Grassy Plains Network and VNPA response to: Draft Casey Fields South and Devon Meadows PSPs

31 March 2025

Figure 1. Image on left shows likelihood of native grassland presence, darker pixels indicating higher likelihood. Image on right shows key areas of grassland presence overlaid on PSP map. Data from ARI/GHCMA 2021.

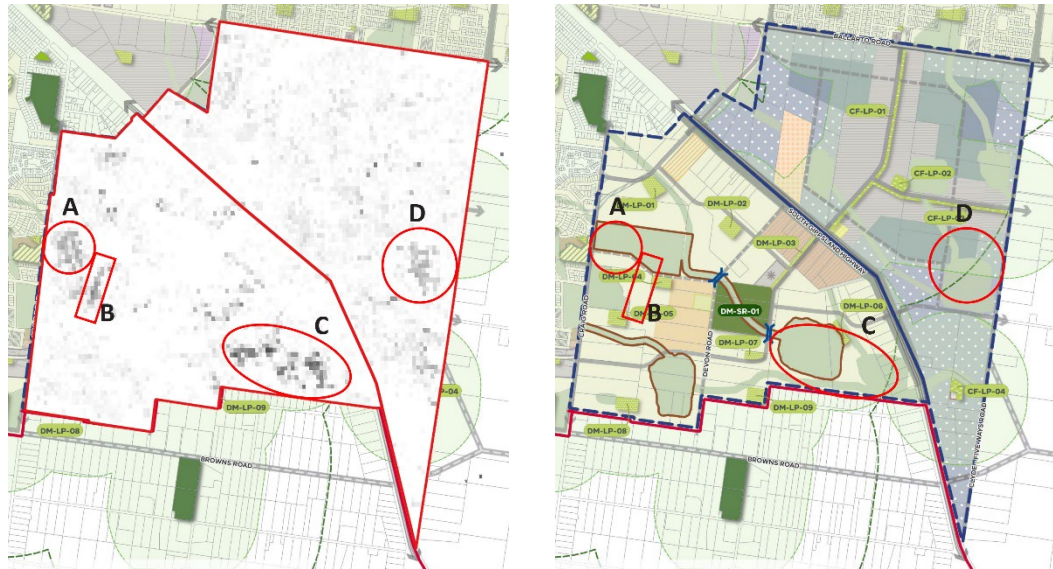
Patch A: A restructuring of the shape of the drainage reserve would allow for more native grassland habitat to be retained within the Southern Brown Bandicoot habitat corridor, improving outcomes for the Southern Brown Bandicoot and native grasslands.

Patch B: The linear nature of this patch suggests a useful north–south connection between the two Southern Brown Bandicoot corridors. This would aid connectivity, build in redundancy, and improve gene flow.

Patch C: Again, some reconfiguring of drainage reserves shapes could allow more existing Southern Brown Bandicoot habitat and grassland to be retained.

Patch D: Some reconfiguring of drainage reserve shape could allow more grassland to be retained.
